FORD 4R100 "UPDATE HANDBOOK"

FORD 4R100 "UPDATE HANDBOOK"

Since the introduction of the 4R100 transmission in model year 1998, there have been many engineering changes to improve Pleaseability, Reliability and Durability concerns. These changes have affected most every part used in this transmission. This "Update Handbook" will explain each change, the reason for the change, and any parts interchangeability concerns created by the change, along with any part numbers needed to update your transmission.

Figure 12

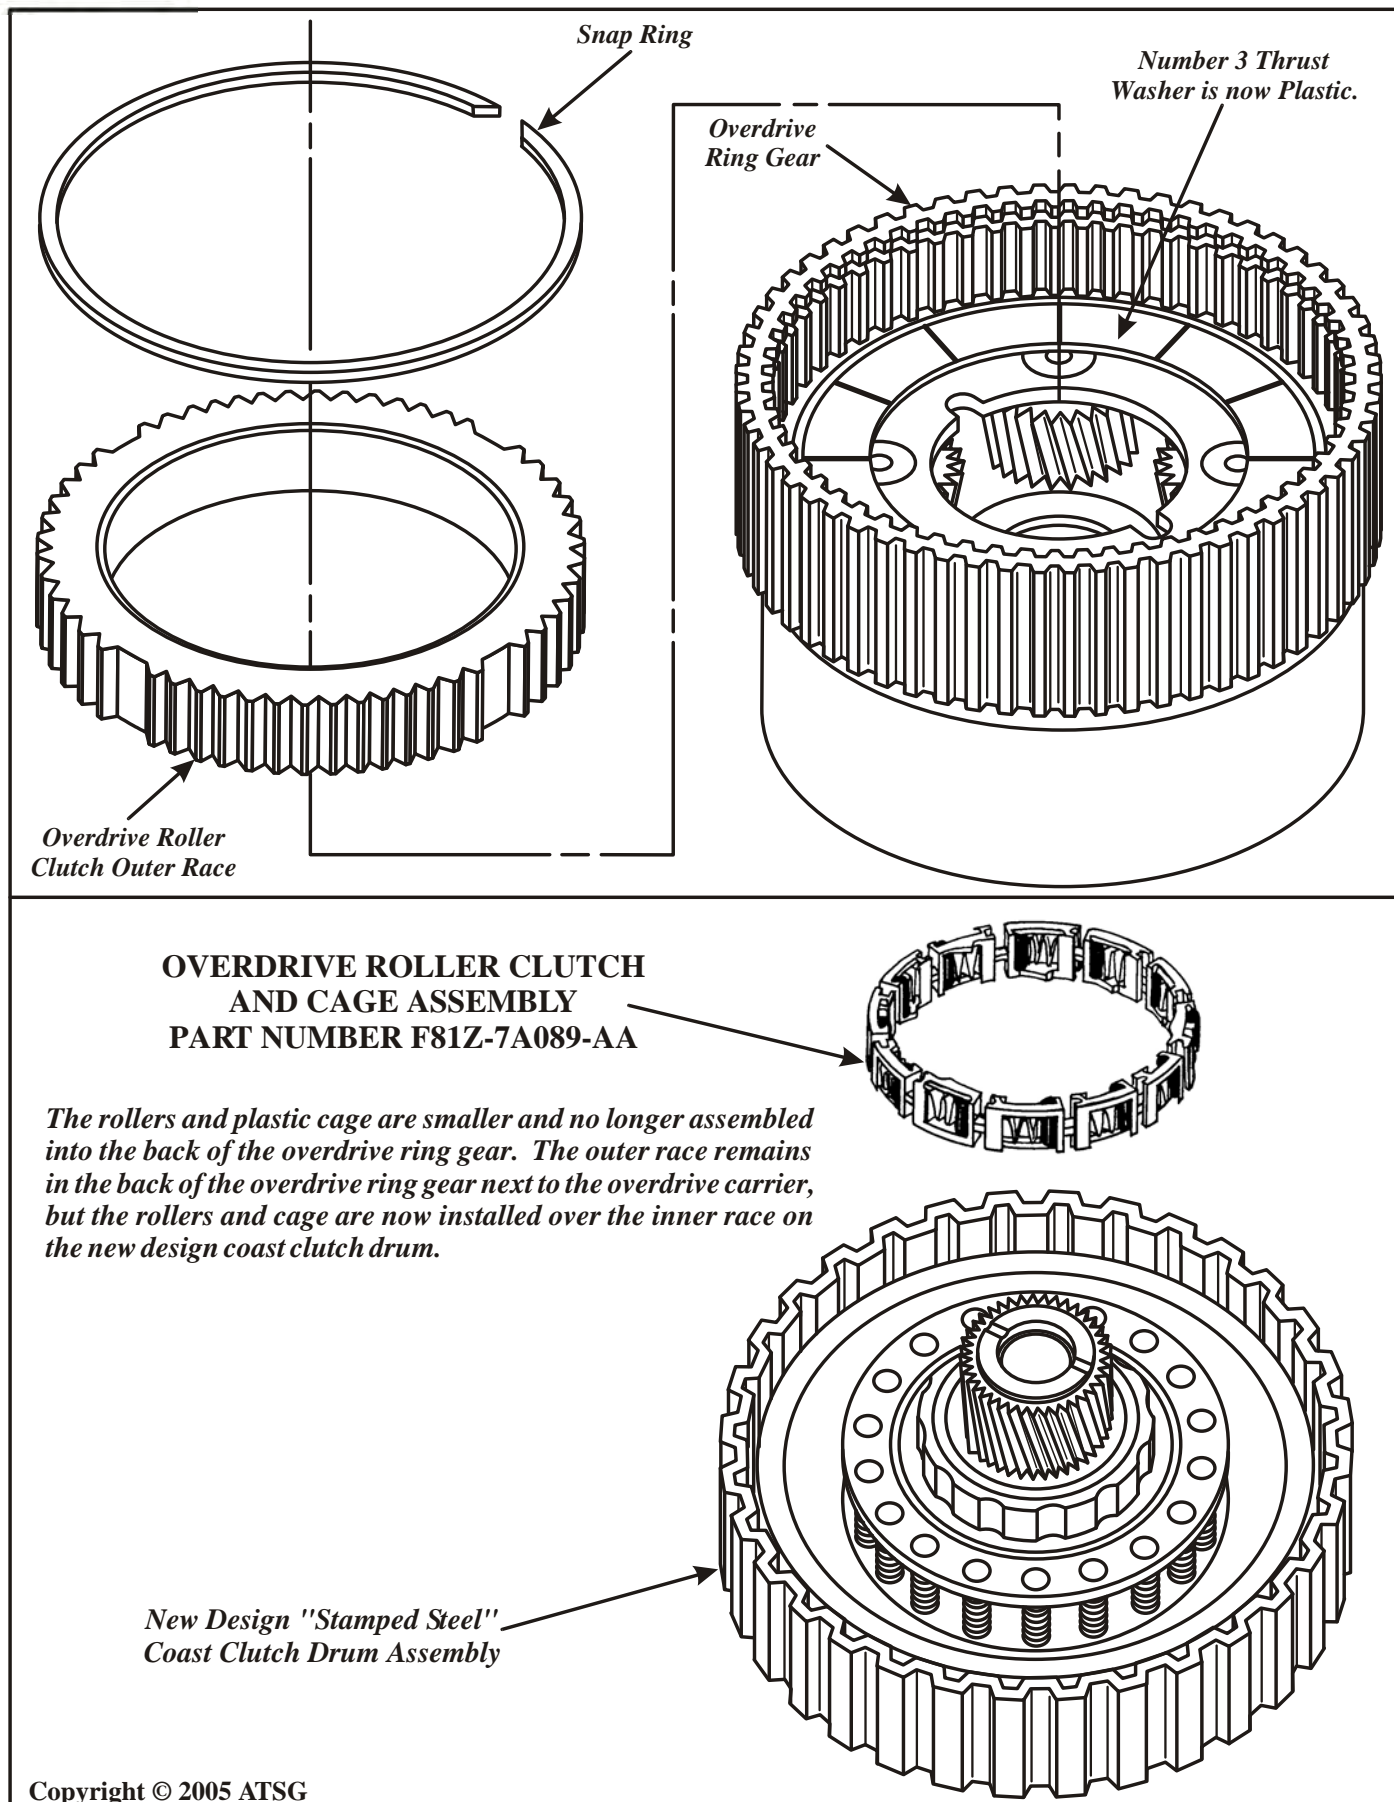
- (12) **COAST CLUTCH PISTON** - The coast clutch piston in the new design coast clutch drum is now a stamped steel, molded rubber seals assembly and is illustrated in Figure 12. The new design piston assembly requires a new seal protector tool, Rotunda No. 307-387, to install the piston and seal assembly into the new design stamped steel coast clutch drum (See Figure 12).

**NEW DESIGN STAMPED STEEL,
MOLDED RUBBER SEAL PISTON
OEM PART NUMBER F81Z-7A262-AA**

**LIP SEAL PROTECTOR
ROTUNDA NO. 307-387**

Figure 15

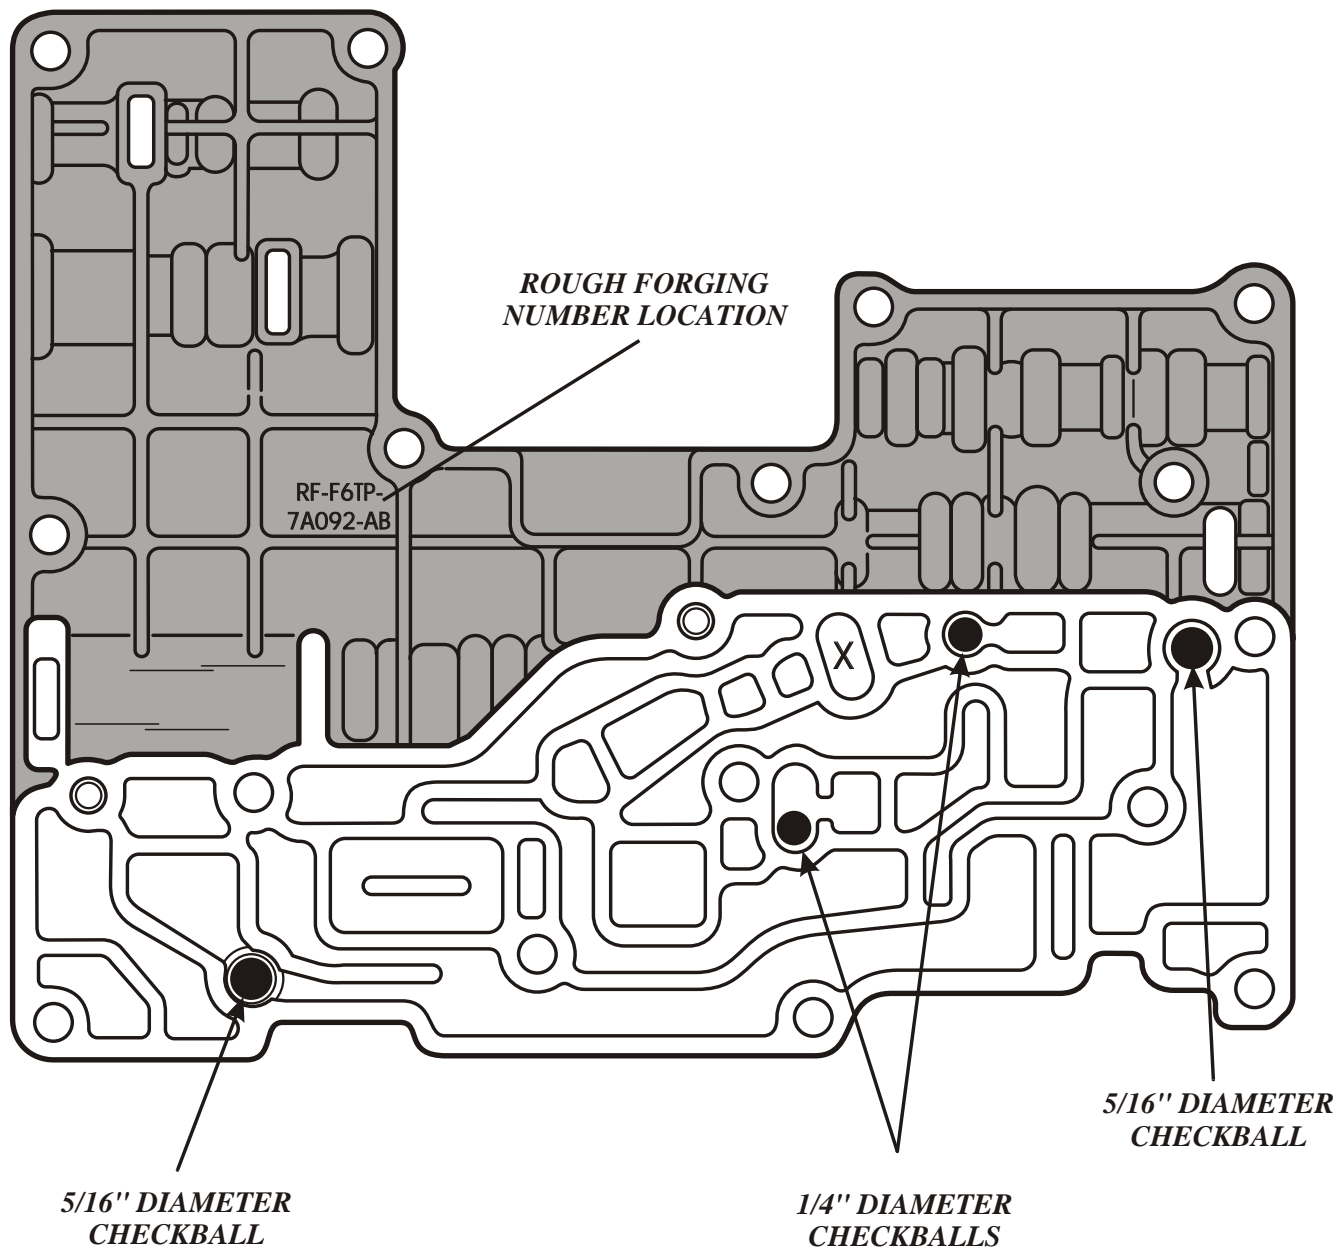
- (15) **VALVE BODY CHECKBALL LOCATIONS** - Valve body checkball locations are illustrated in Figure 15 and now has two 1/4" checkballs and two 5/16" checkballs. This of course changes the lower valve body spacer plate as illustrated in Figure 16. The new design spacer plate has only one hole over the bathtub where the checkball was removed. The case checkball locations remain the same as the 1996-Up configuration, and this illustration is included for reference and shown in Figure 17.

**4R100 VALVE BODY CHECKBALL LOCATIONS
REQUIRES TWO 1/4" RUBBER BALLS,
AND TWO 5/16" RUBBER BALLS**

Figure 30

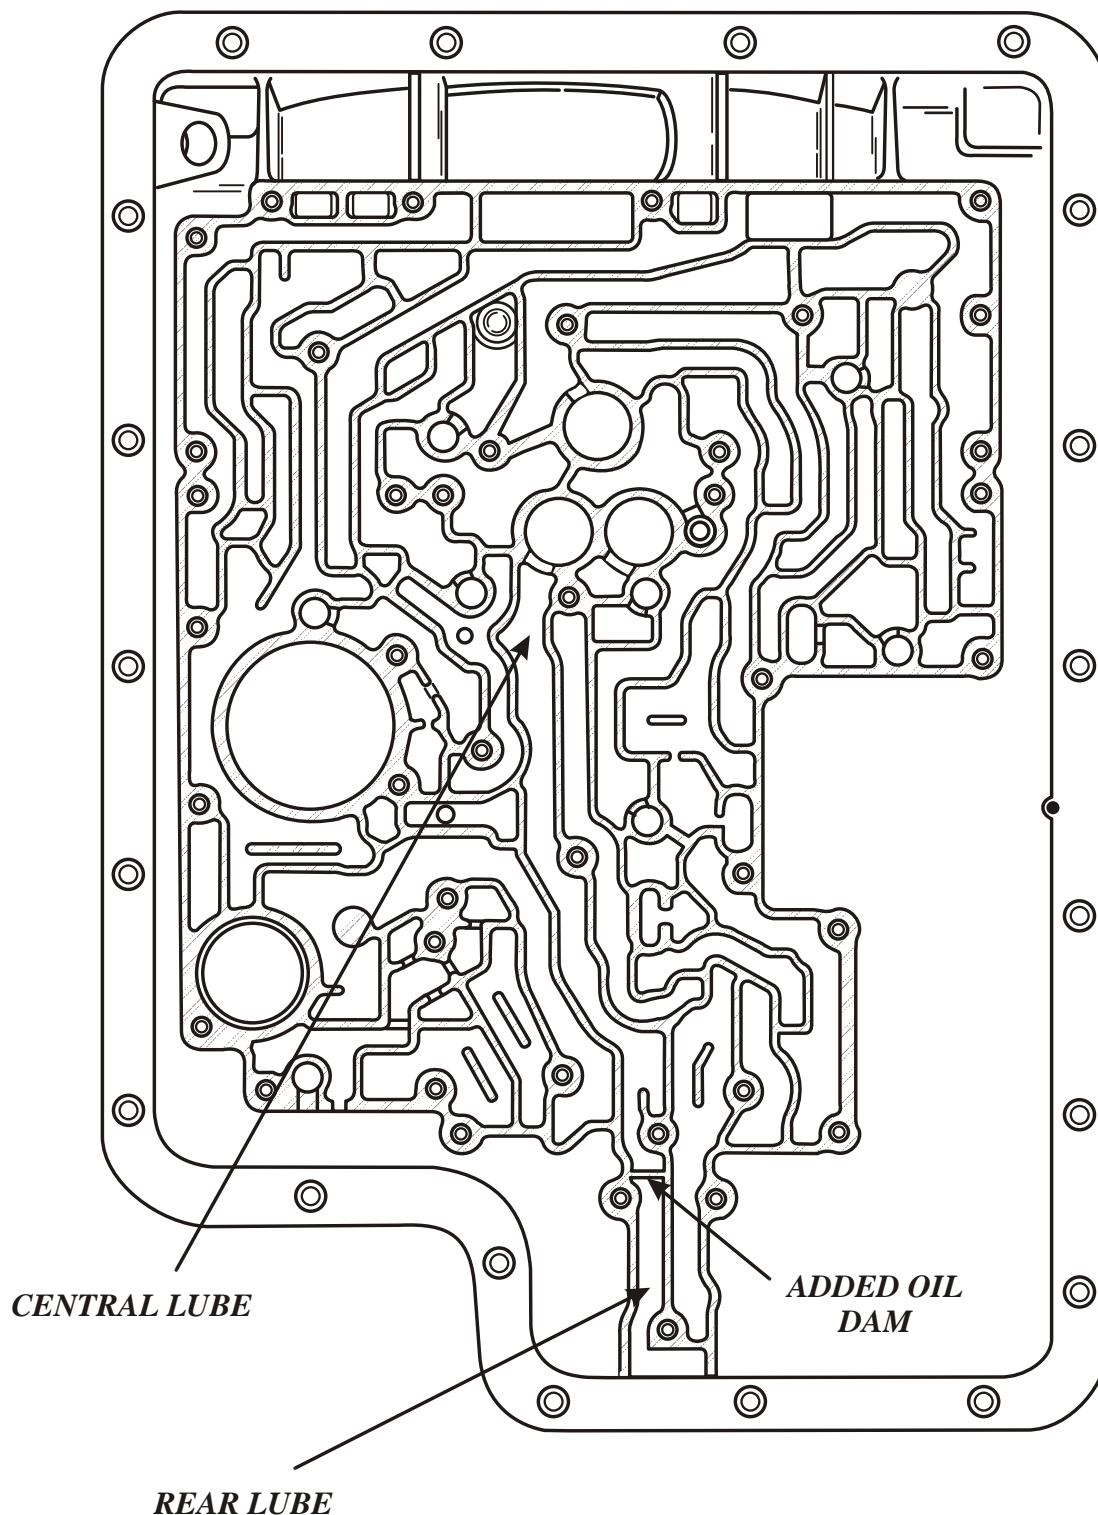
- (1) **TRANSMISSION CASE:** The transmission case was changed to accommodate the "PTO" window, as previously shown in this manual. All 4R100 Cases, "NON-PTO" and "PTO," also had a "Dam" added to separate "Rear Lube" and to incorporate "Central Lube" as shown in Figure 30.

Figure 32

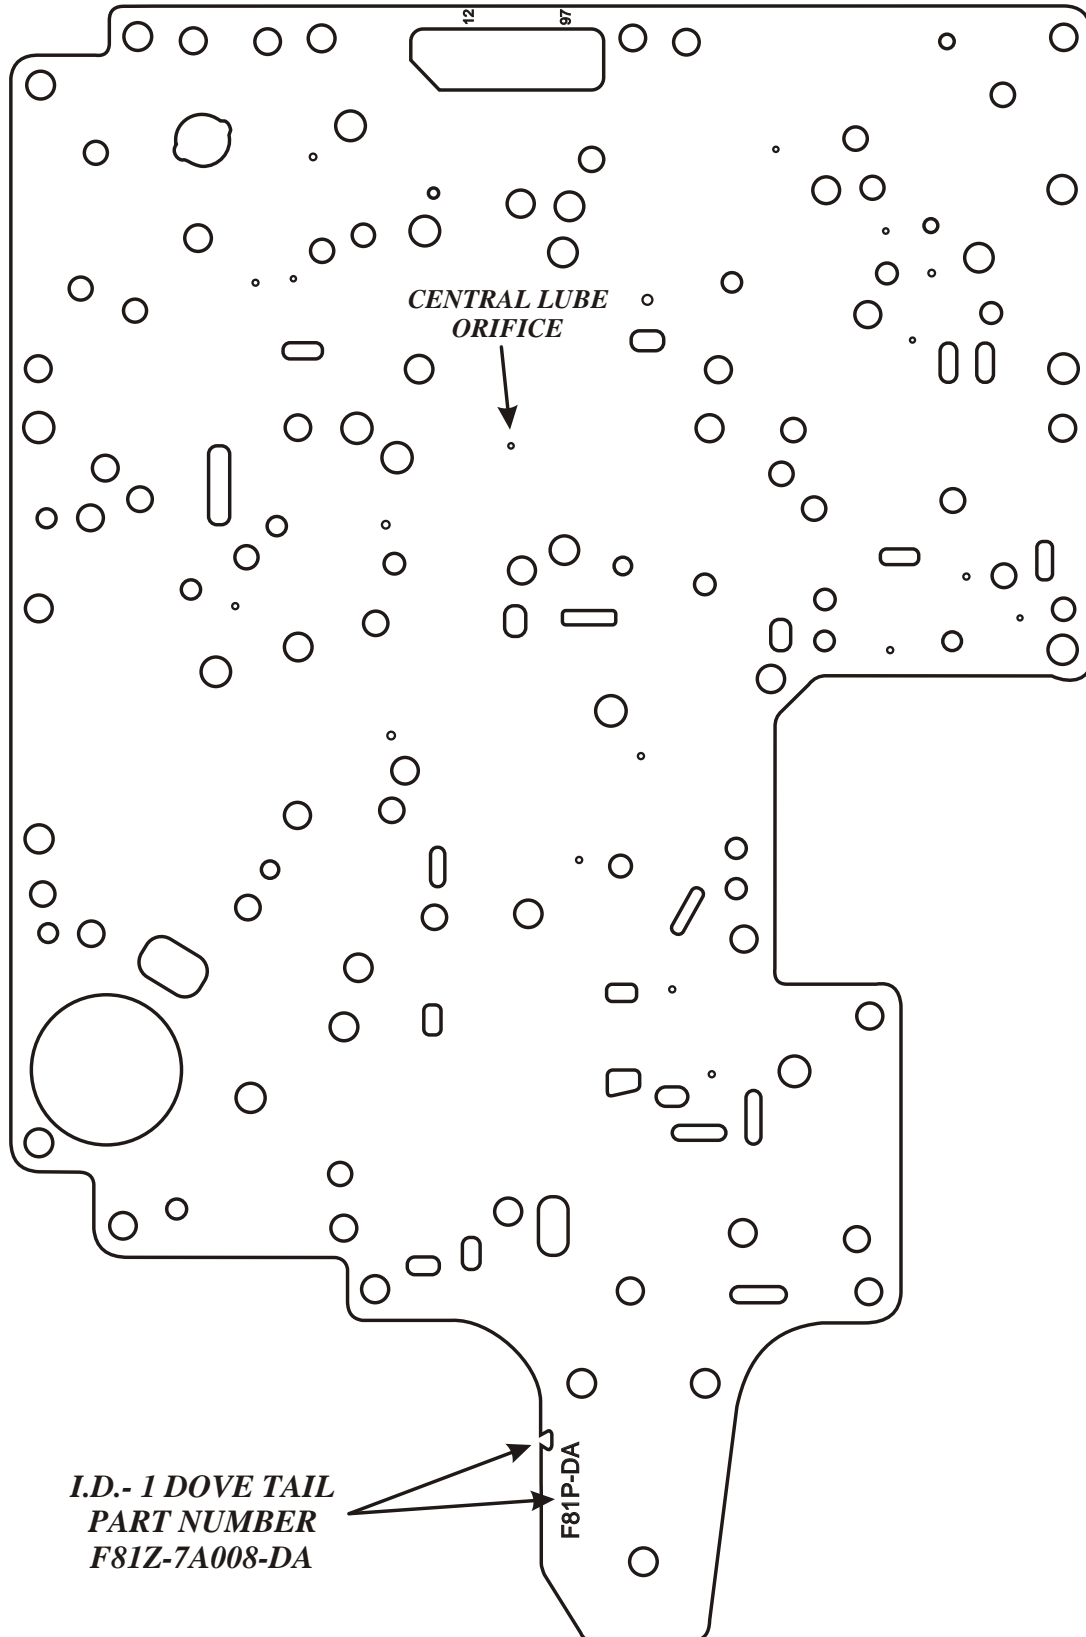
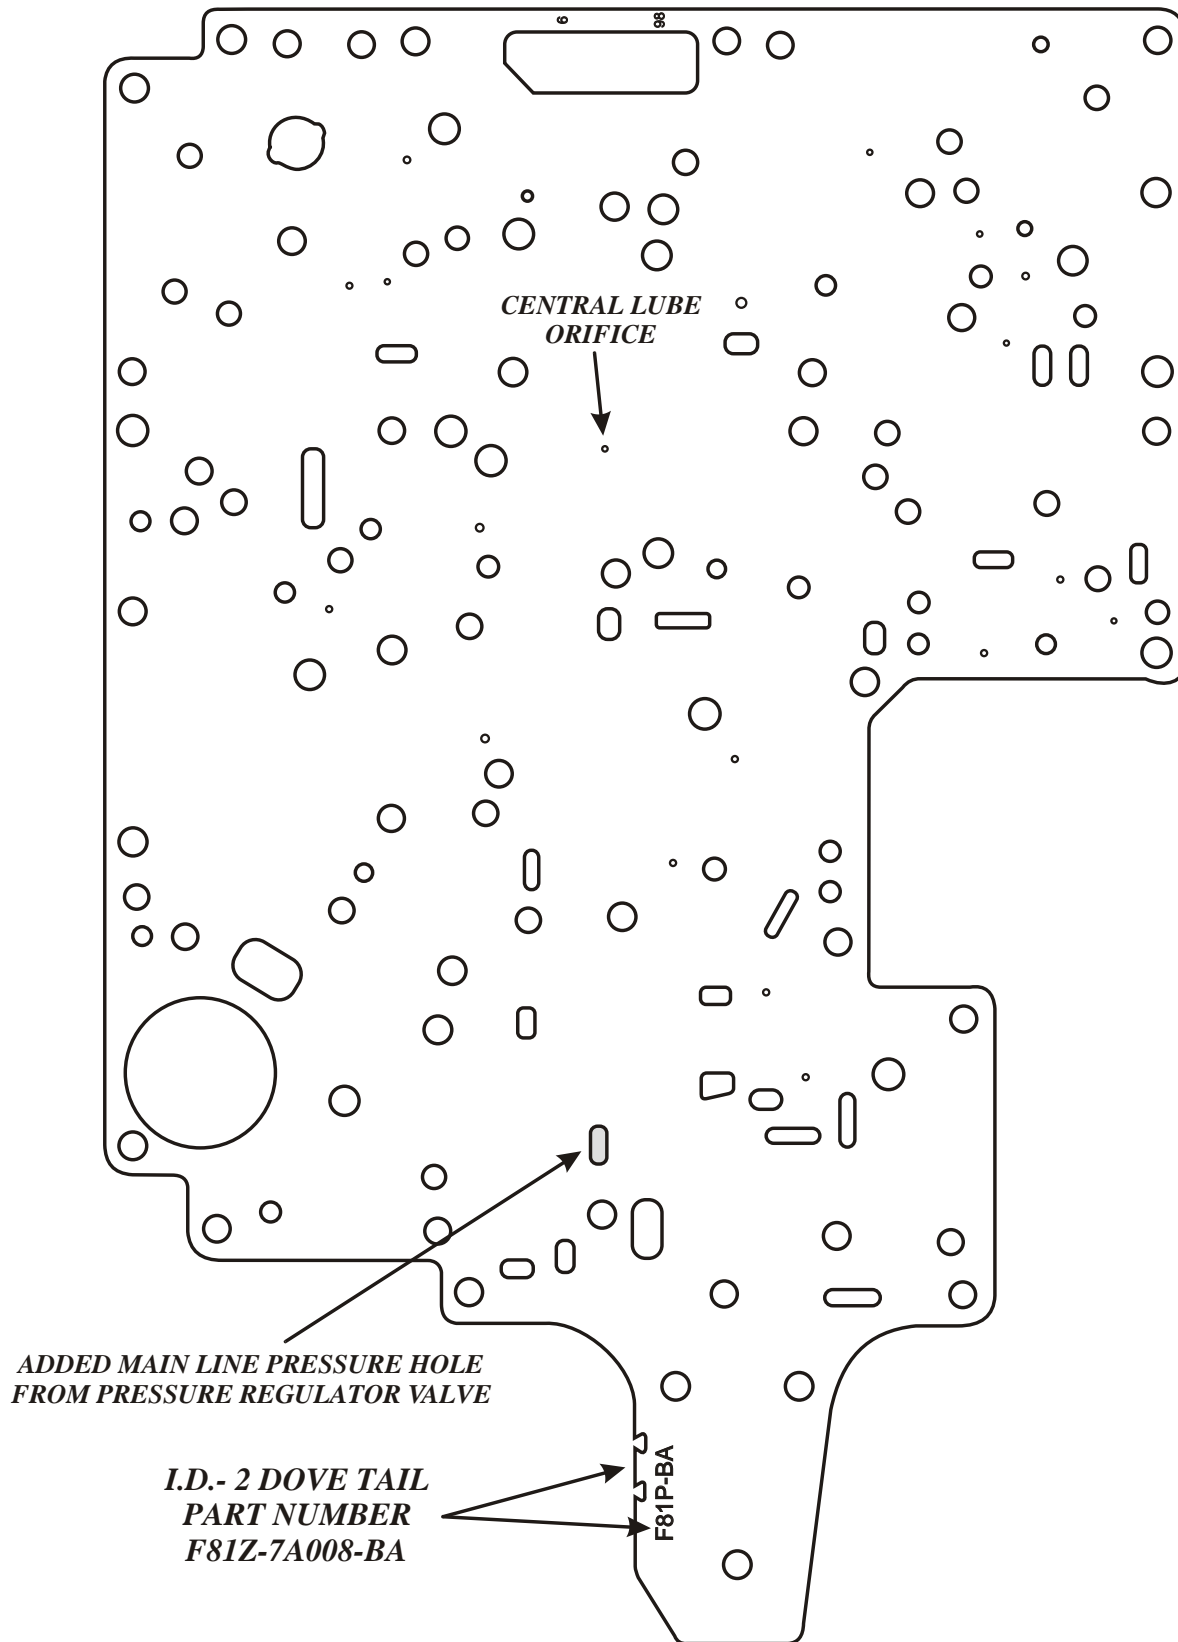
- (2) **VALVE BODY TO CASE SPACER PLATE:** The Valve Body to Case Spacer plate on the "PTO" versions had a hole added, to supply the 3-4 Shift Valve with Line Pressure, as shown in Figure 32. A hole was also added to the Spacer Plate on "NON-PTO" and "PTO" versions to connect "Solenoid Regulator Valve" oil to supply "Central Lubrication." Refer to Figures 31 and 32 for identification of "NON-PTO" and "PTO" Valve Body To Case Spacer Plates.

Valve Body To Case Spacer Plate (Non-PTO)F81Z-7A008-DA
Valve Body To Case Spacer Plate (PTO)F81Z-7A008-BA
